**ADDENDUM NO. 1
TO THE
SPECIFICATIONS AND CONTRACT DOCUMENTS**

City Project No. FAC23008O

City Hall Generator

November 24th, 2025

E601

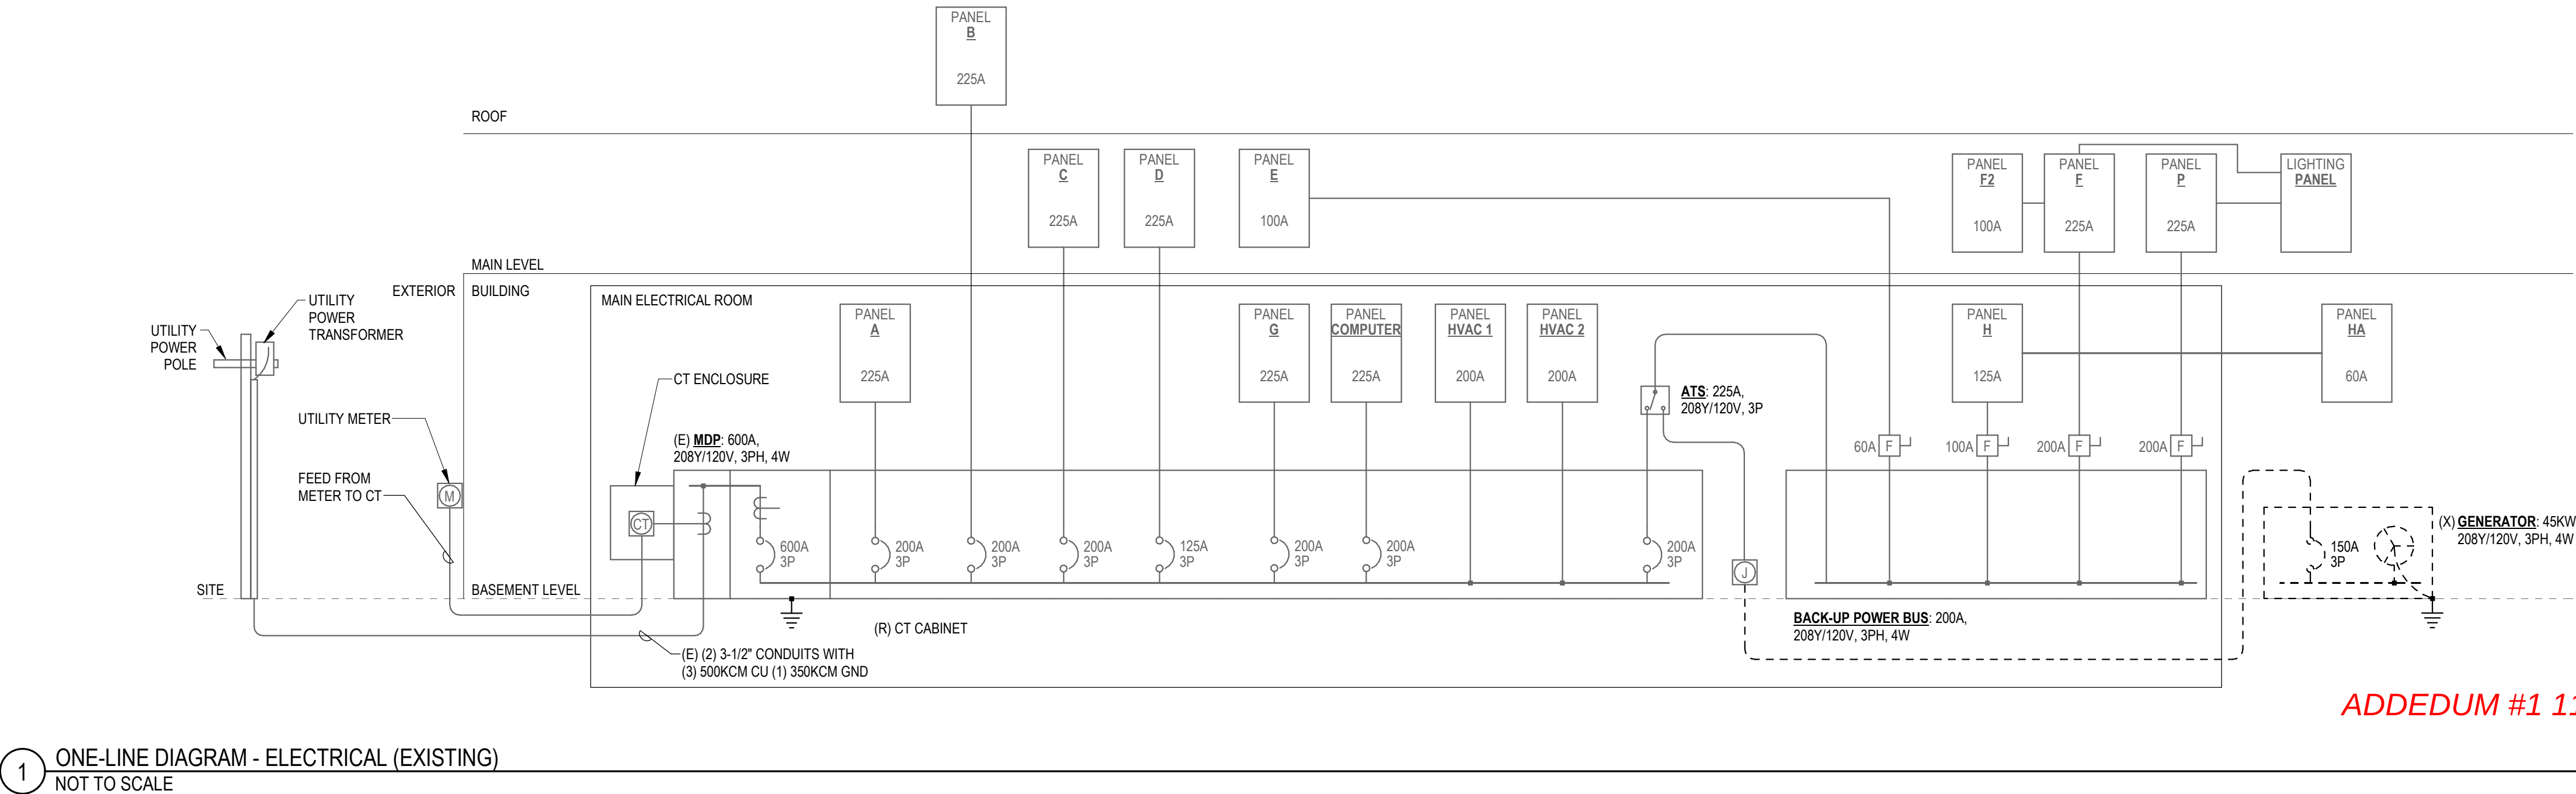
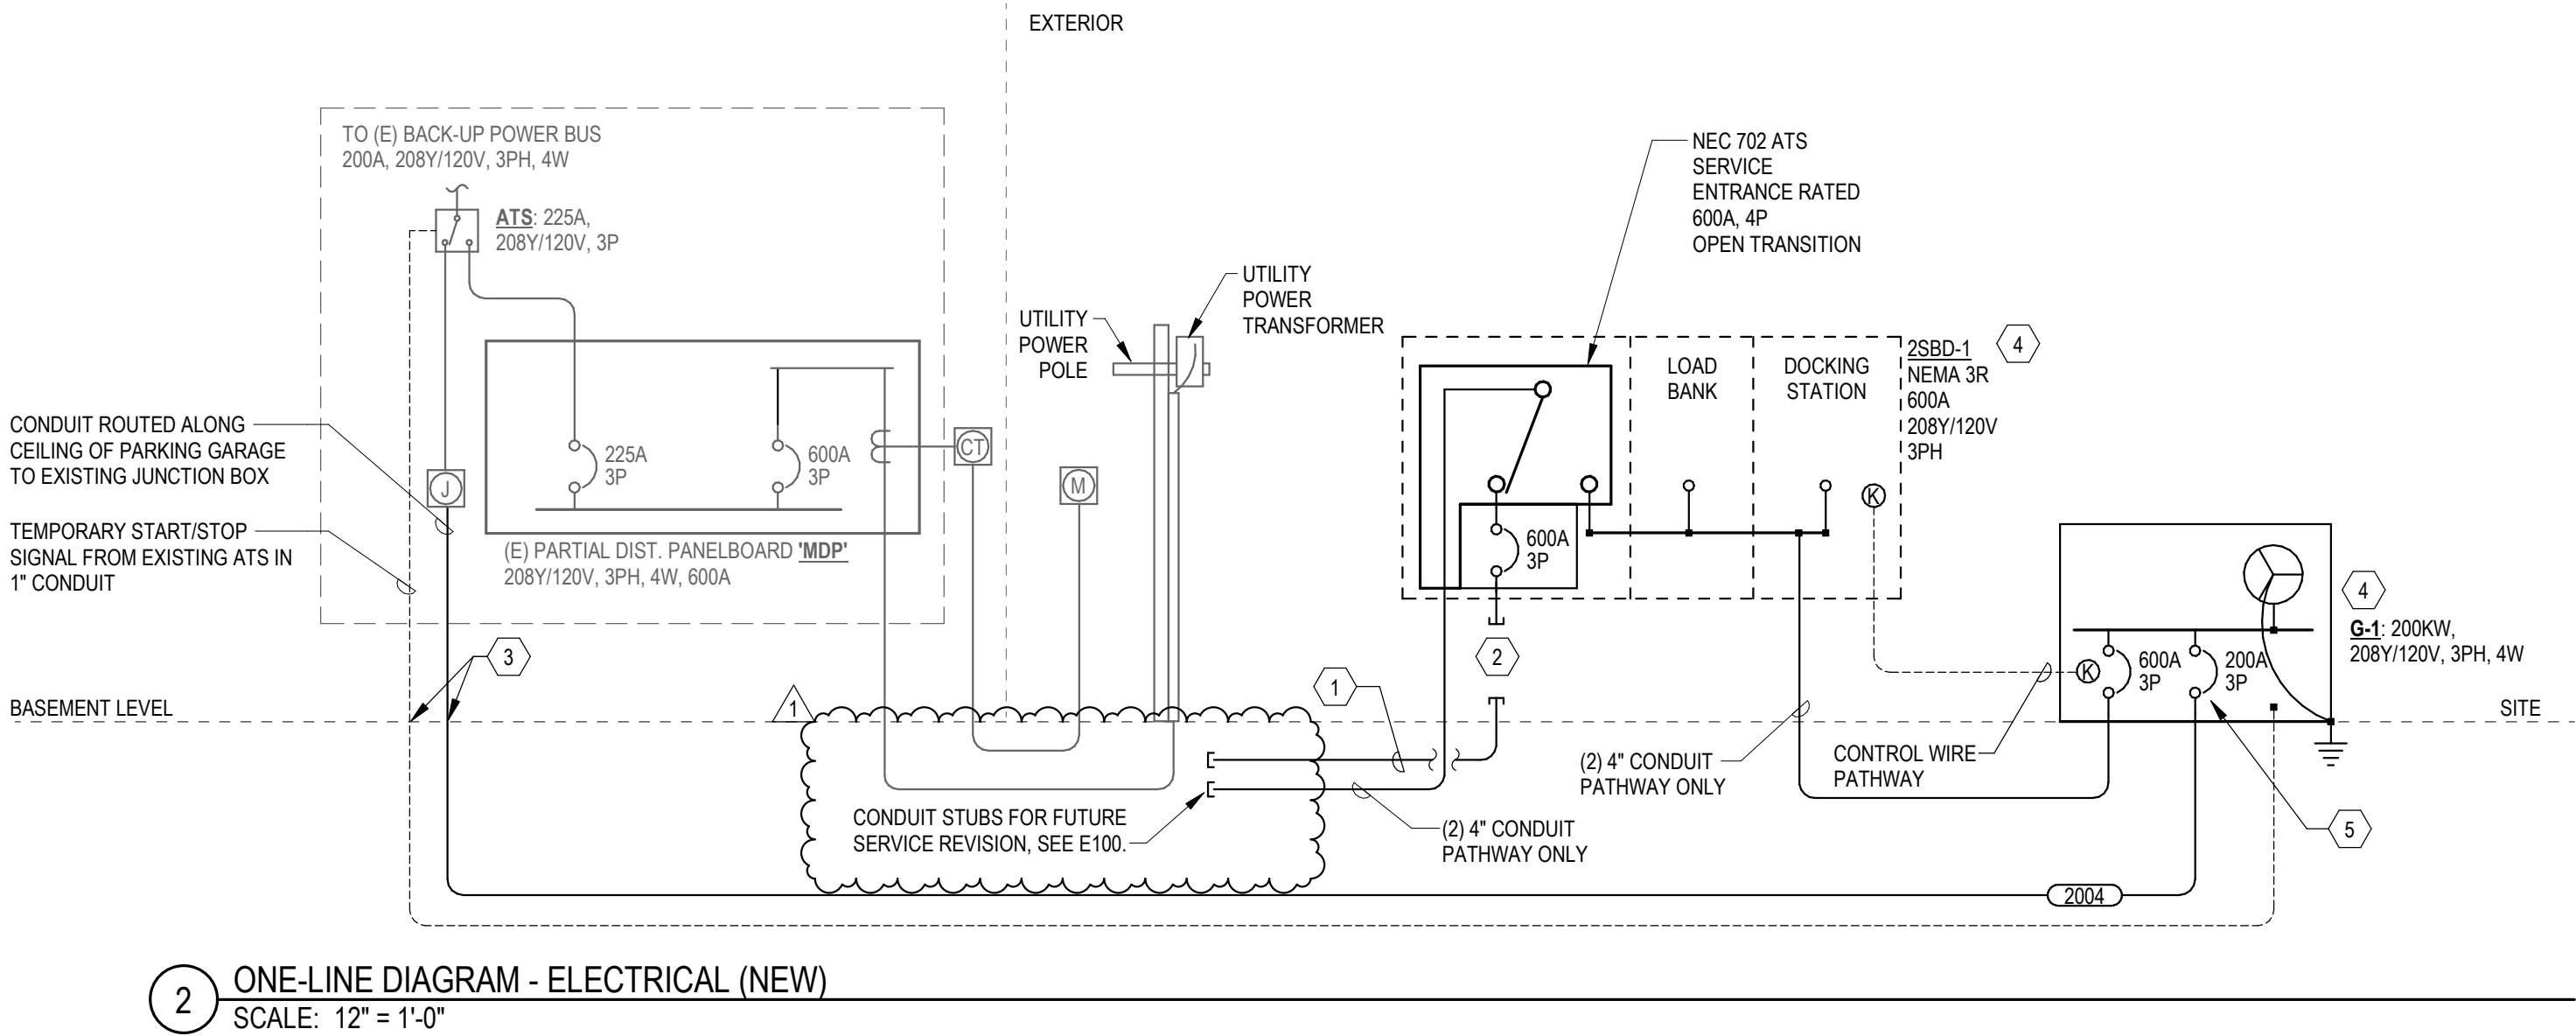
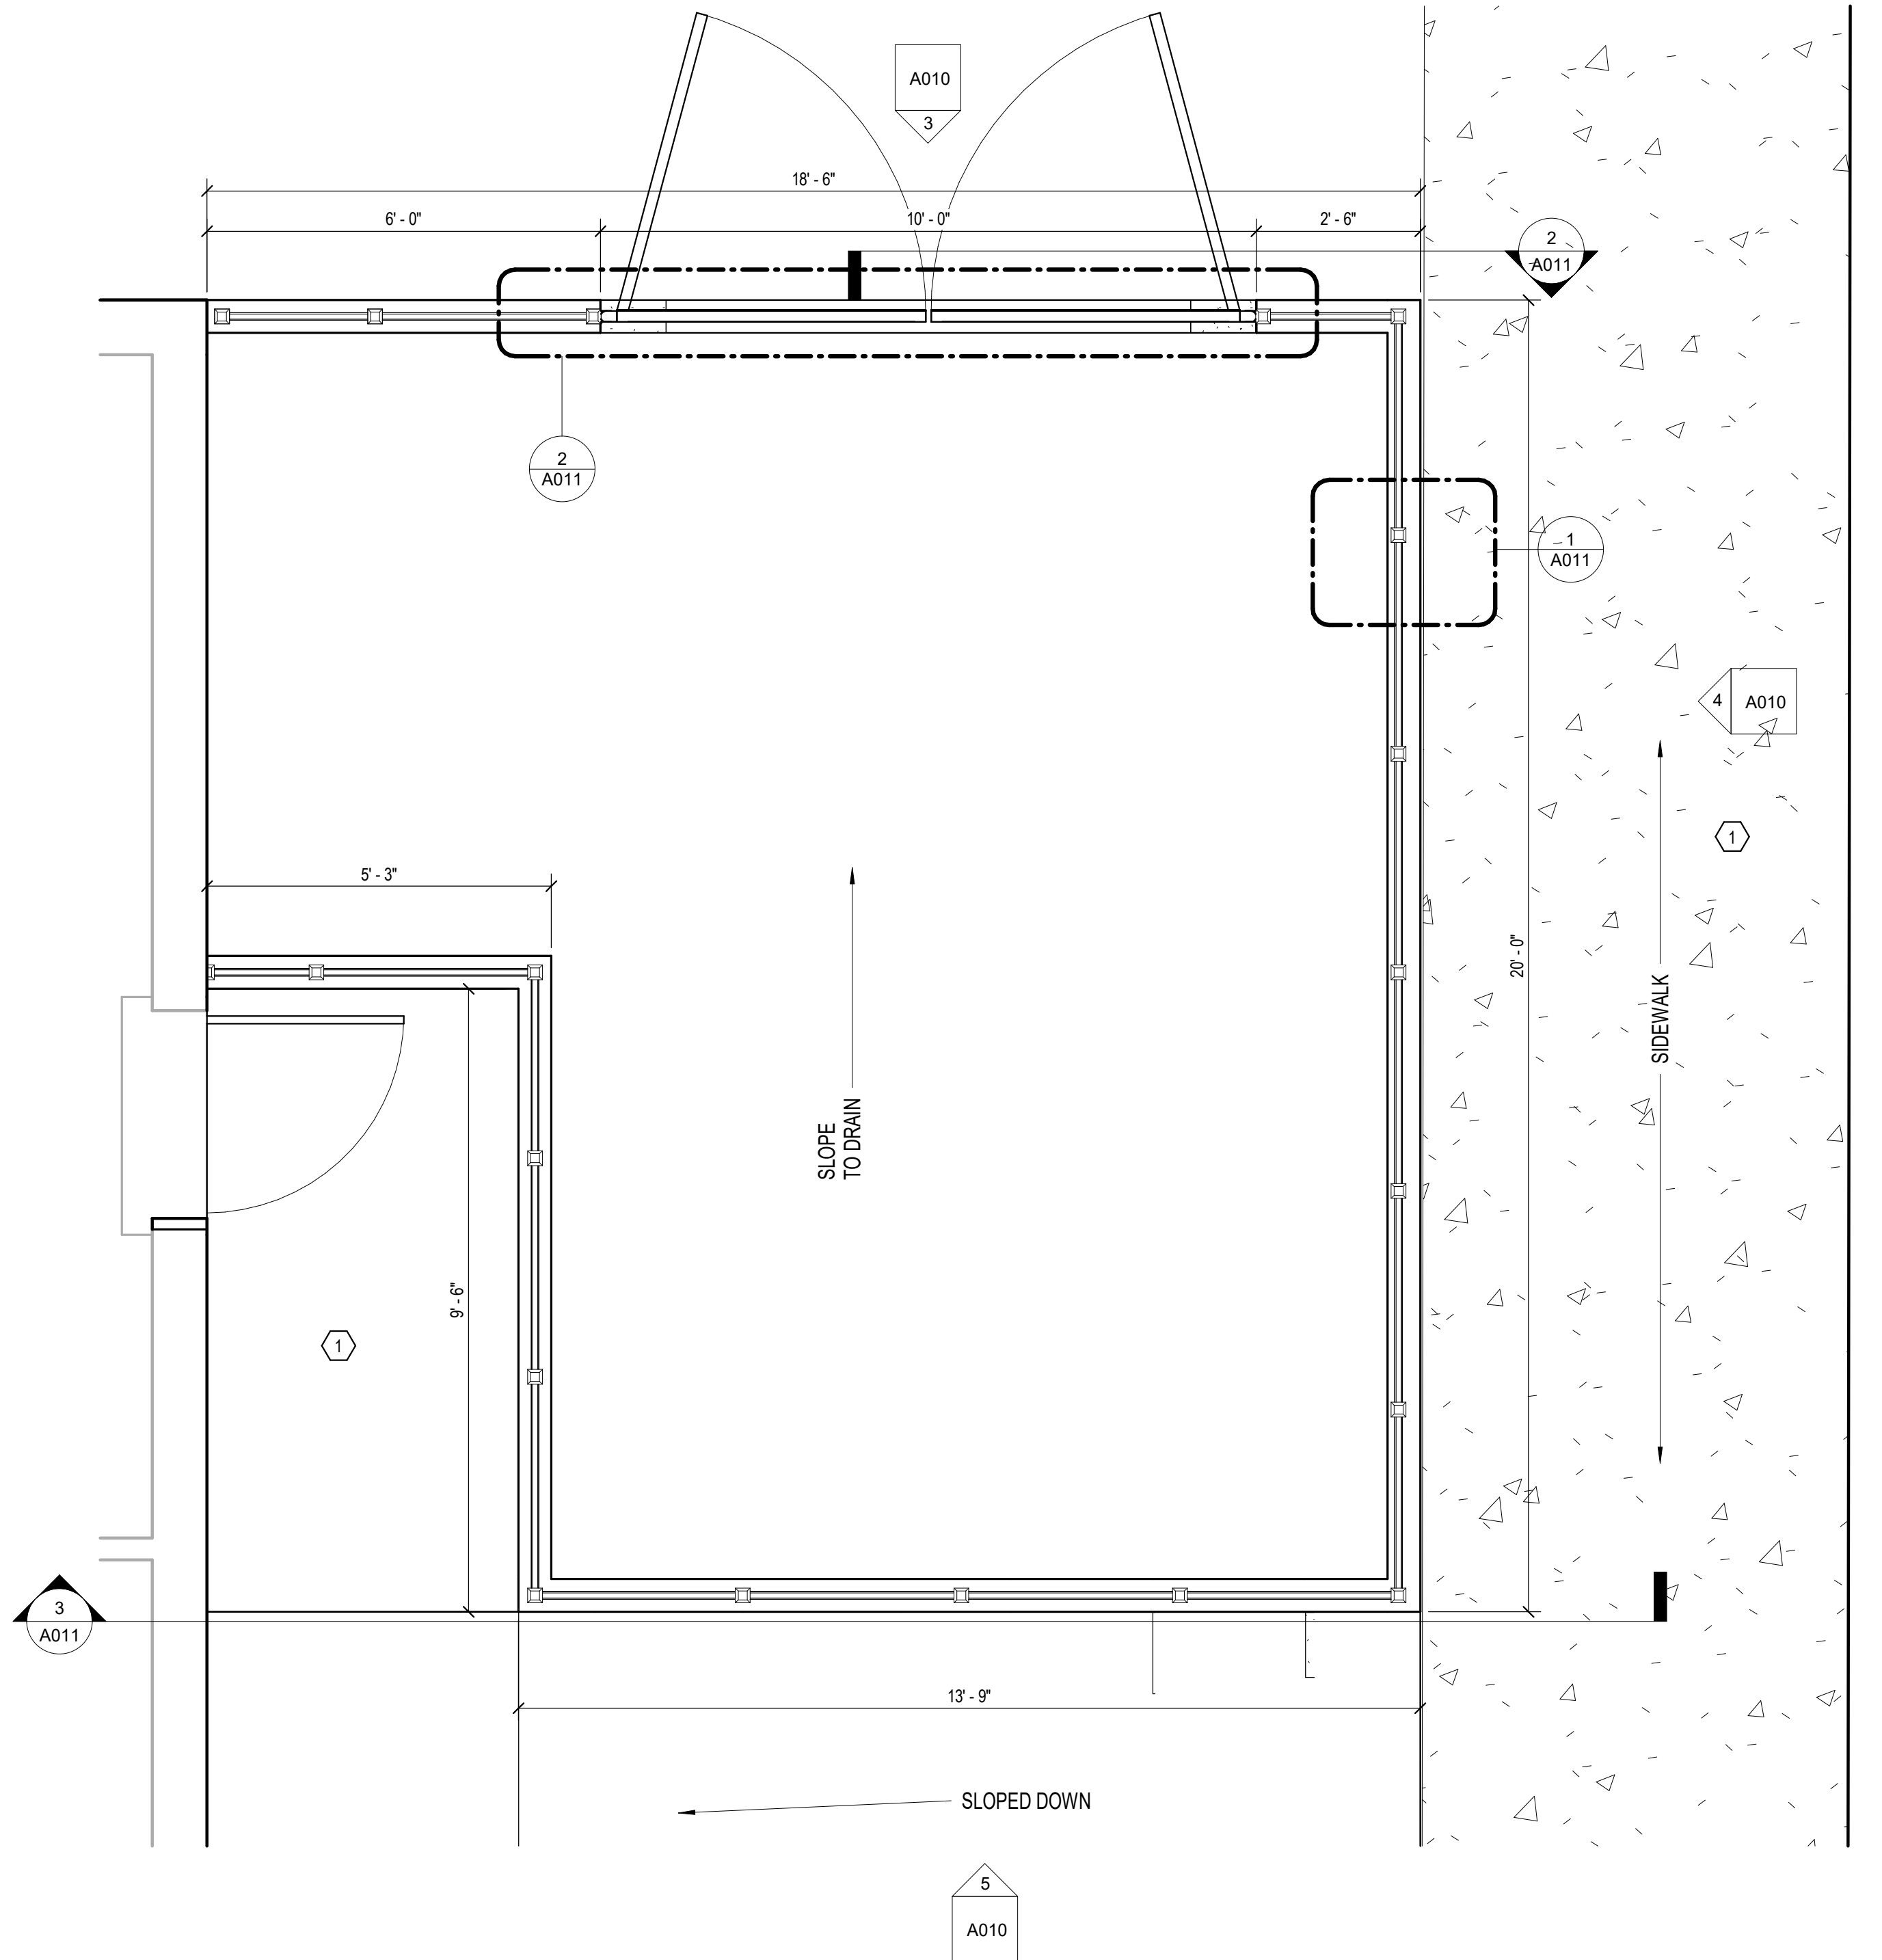
Electrical Scope: The underground utility vault between Clark Public Utilities (CPU) existing power pole and existing CPU meter location has been revised. There will be no Clark Public Utilities involvement on this project. See revised electrical plan sheets.

Electrical Plan Sheets E100 and E601

Delete plan sheet E100 and E601 in their entirety and replace with revised plan sheets.
See attach plan sheet E100 and E60.
